# PLANNING BOARD REPORT PORTLAND, MAINE

Baxter Academy for Technology and Science  
185 Lancaster Street  
Level III and Traffic Movement Permit  
2017-022  
Baxter Academies of Maine, Applicant

| Submitted to Portland Planning Board<br>Public Hearing Date: March 28, 2017 | Prepared by: Shukria Wiar<br>Date: March 24, 2017 |

Figure 3: Layout of the new sidewalk and bicycle parking across Lancaster Street.

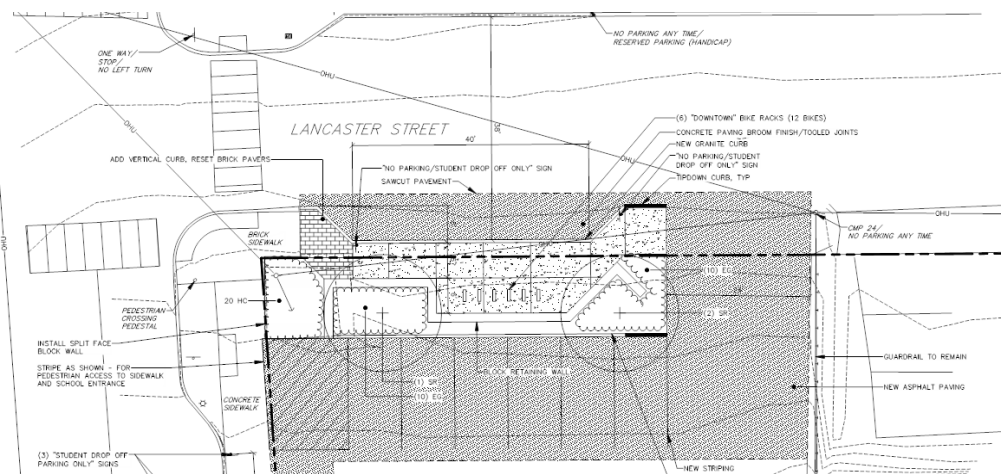
Staff Comments: The surface parking area is an existing lot. The seven parking spaces that back out on Lancaster Street will be eliminated as part of this project and replaced with a sidewalk, bicycle spaces, and some landscaping. The rest of the surface parking lot will not be improved. The improvements meet city standards.

The seven spaces that back out on Lancaster Street will be eliminated as part of this project and replaced with a sidewalk, bicycle spaces, and landscaping. This area may be the only opportunity for landscaping on the proposed site; the rest of the surface parking lot will not be improved. Jeff Tarling has reviewed the proposed landscaping and finds it acceptable.
